CITY OF ARCADIA  
Public Works Services Department

**Addendum Number 2  
REQUEST FOR PROPOSALS  
Orange Grove PFAS Treatment System  
and Facility Improvements Project  
Project No. 72863226**

**The intent of this Addendum No. 2 is to provide preliminary layout for the prefabricated office building; specify the concrete pad thickness of the existing maintenance building; revise Section B 4.0, Non-Collusion Affidavit, of Appendix B; clarify the facility shutdown requirements, backwash tank design, and required level of SCADA/controls integration; and extend the Request for Proposals (RFP) submission deadline.**

PROPOSED PRE-FABRICATED  
OFFICE BUILDING

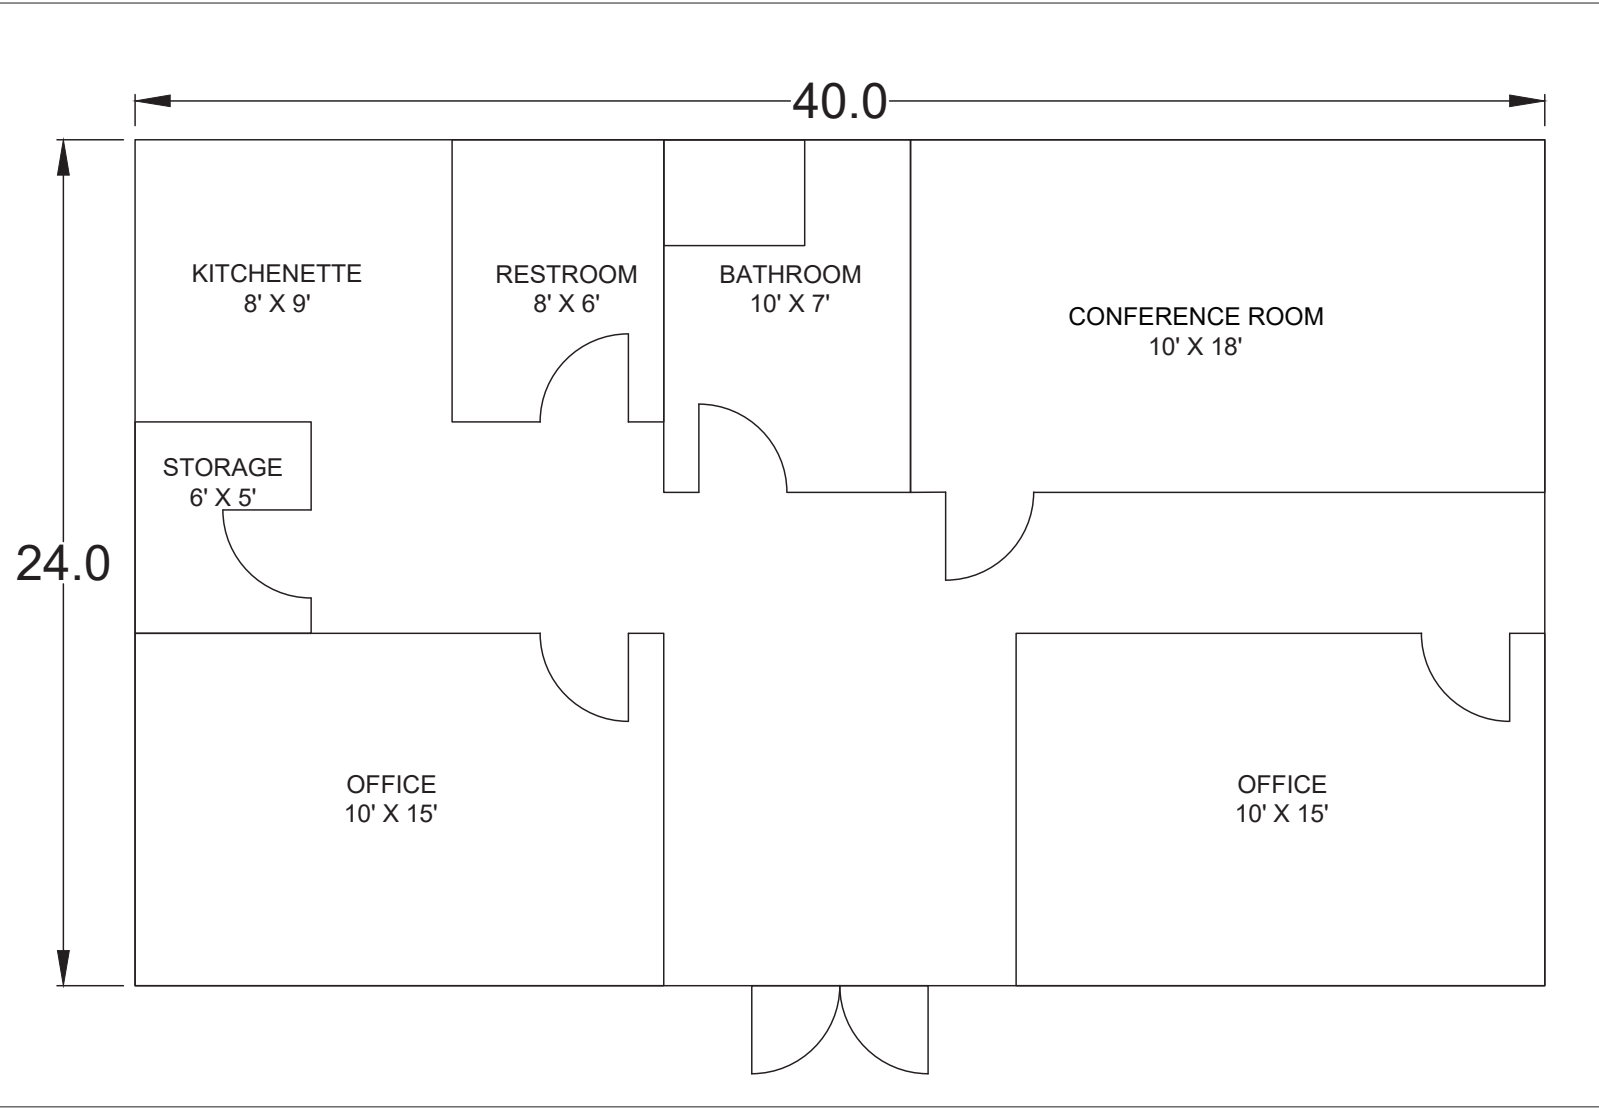
1. Preliminary layout for the prefabricated office building is provided.
2. Concrete pad thickness of the existing maintenance building is 6.25 inches.
3. Section B 4.0, Non-Collusion Affidavit, of Appendix B is revised to read as follows: *"The Proposer shall submit a Non-Collusion Affidavit in the form of the completed Form H as set forth in Appendix C included herewith."*
4. **Maximum allowable shutdown durations:** The only prolonged shutdowns permitted are for the four (4) water wells. These wells may be taken out of service for a reasonable duration, as proposed by each Proposer, to accommodate well-specific work and coordination. The booster station and reservoirs shall remain in service throughout the project. Limited shutdowns of four (4) to six (6) hours for the booster stations may be scheduled during normal working hours.
